State of Michigan
Department of Environmental Quality

Dam Removal

File No. 02-37-0003-P

PUBLIC NOTICE

PROP. RIVER WEIR - PLAN VIEW

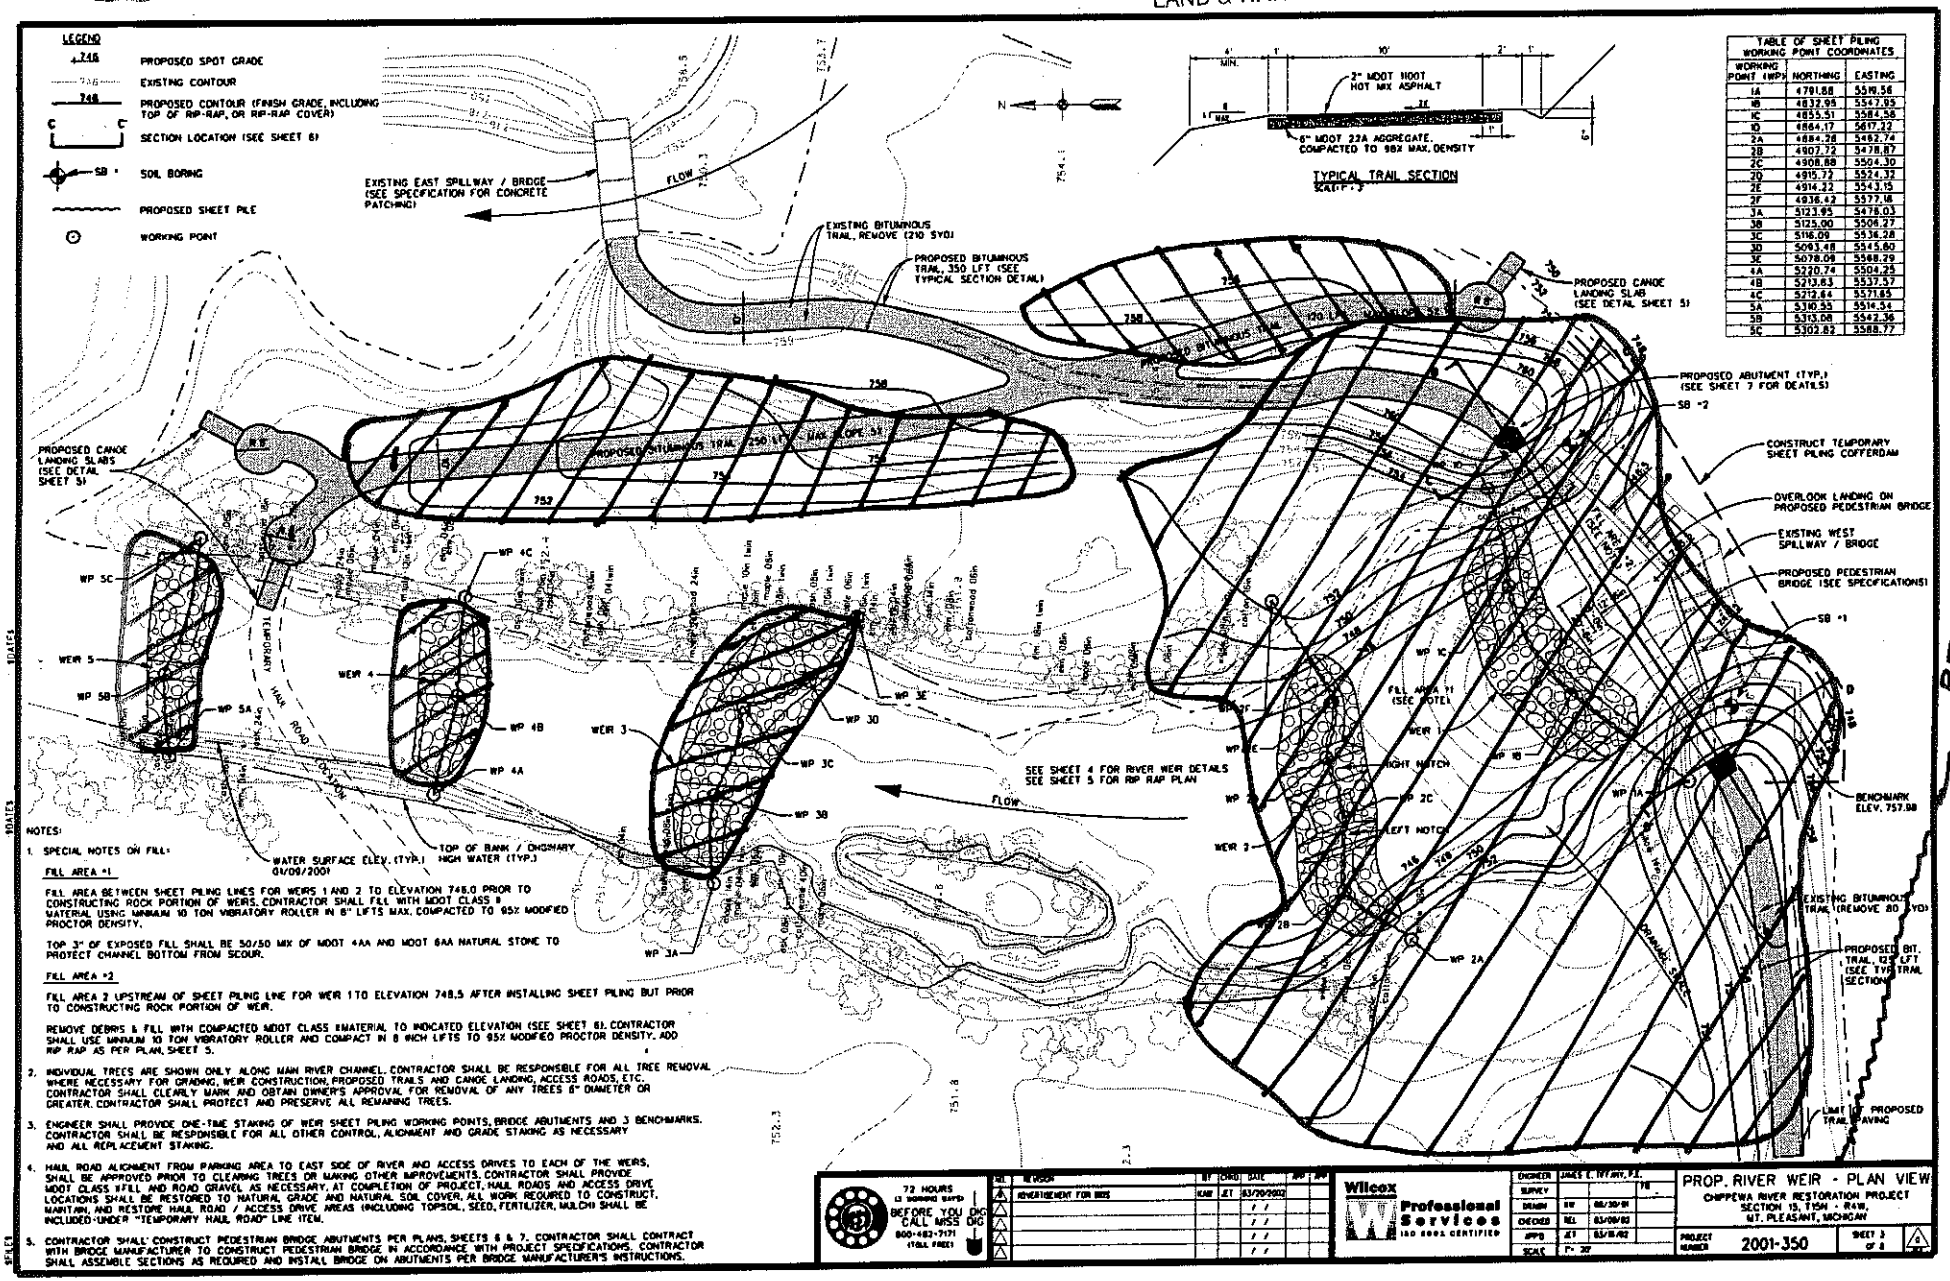
(3) a. project site plan that shows the floodplain boundaries and elevations (if known), and shows all area of proposed floodplain fill and floodplain excavation (cross hatched or shaded)

(7) Linear feet of sheet pile proposed for above the existing dam, and for each of the weirs.

The linear feet of sheet pile walls are provided in the following table:

PROP. RIVER WEIR - PLAN VIEW

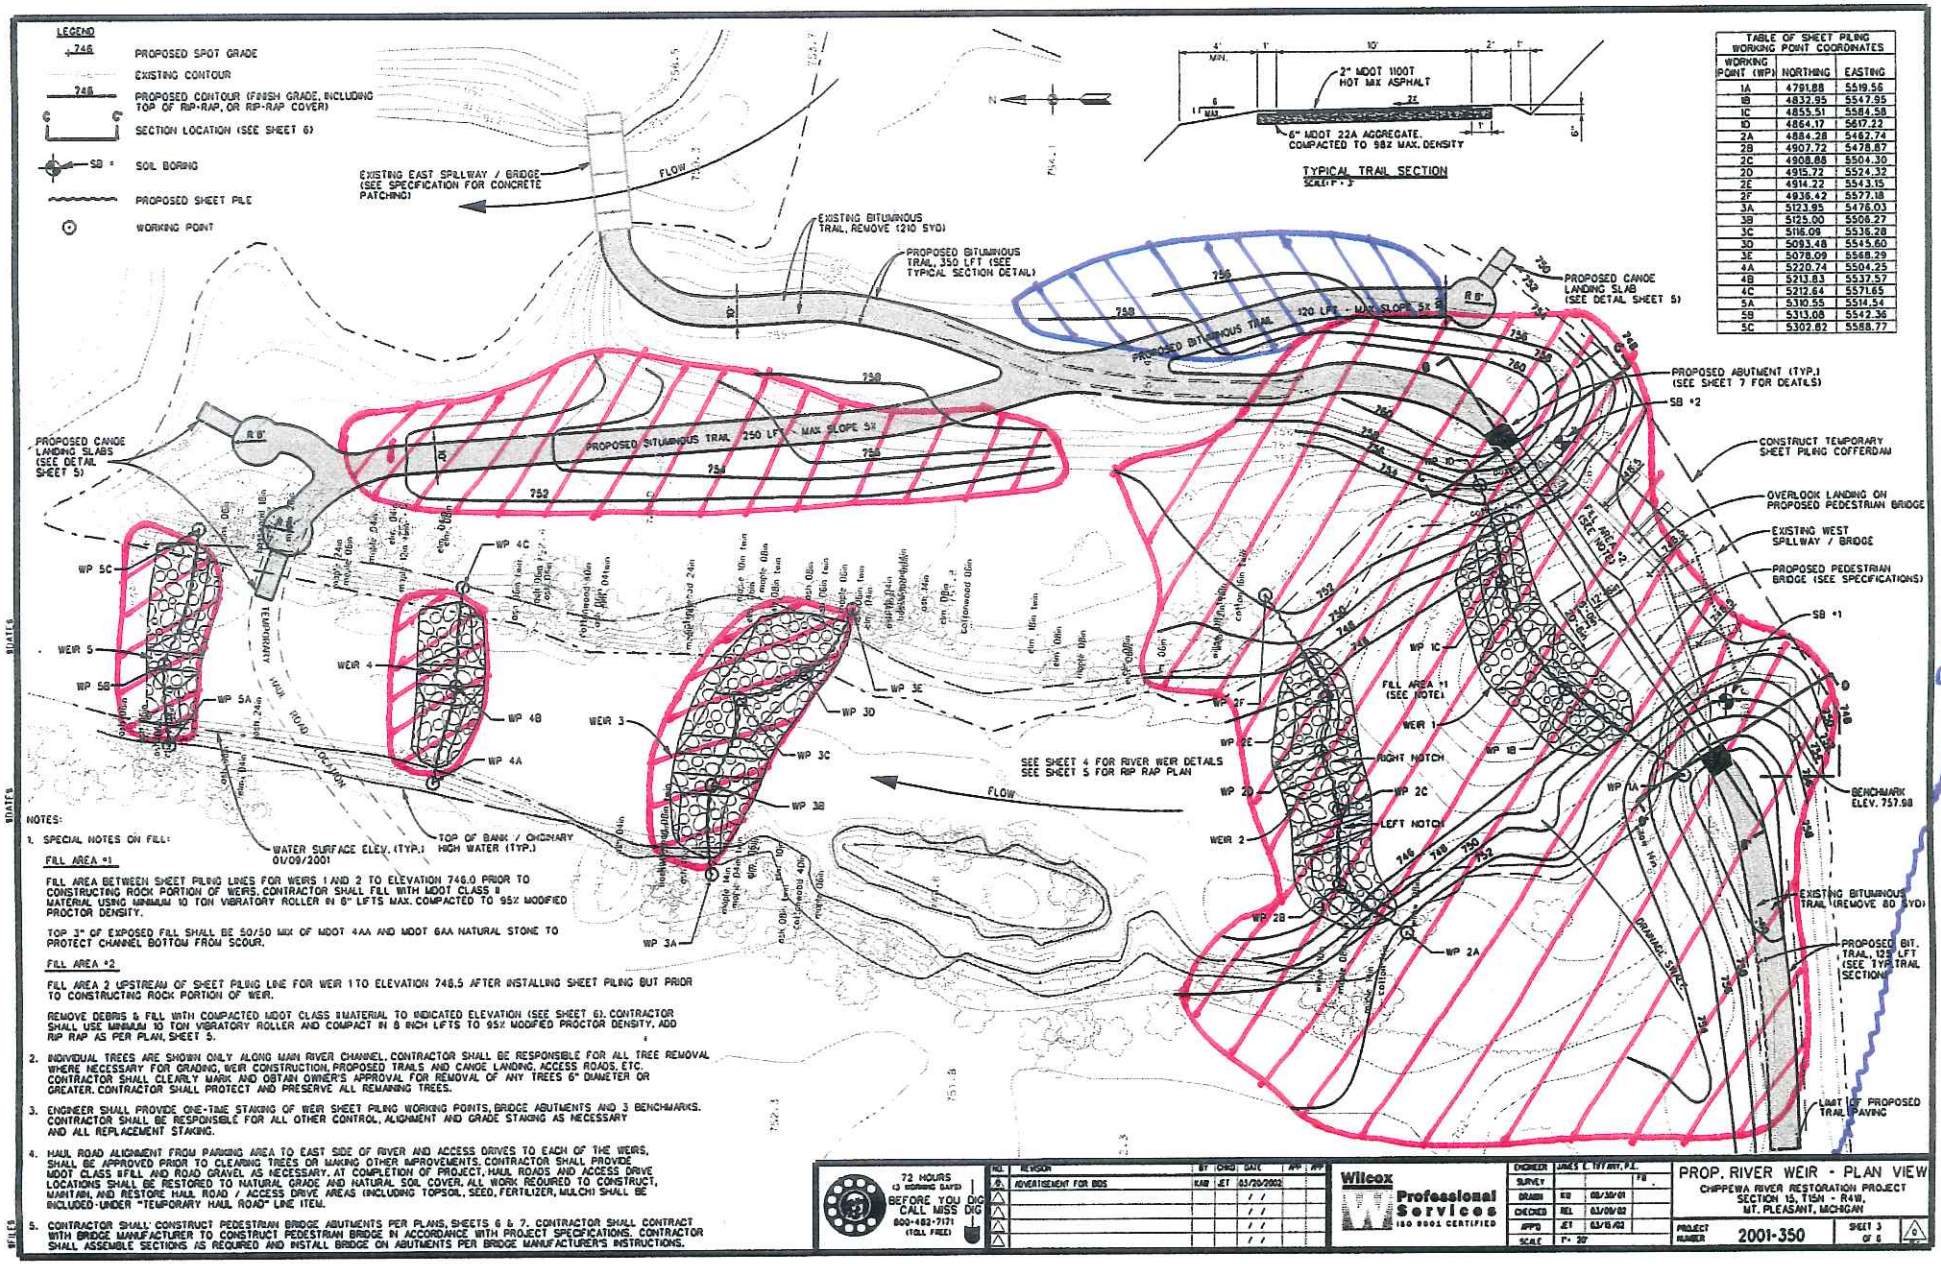
(3) a. project site plan that shows the floodplain boundaries and elevations (if known), and shows all area of proposed floodplain fill and floodplain excavation (cross hatched or shaded)

(7) Linear feet of sheet pile proposed for above the existing dam, and for each of the weirs.

The linear feet of sheet pile walls are provided in the following table:
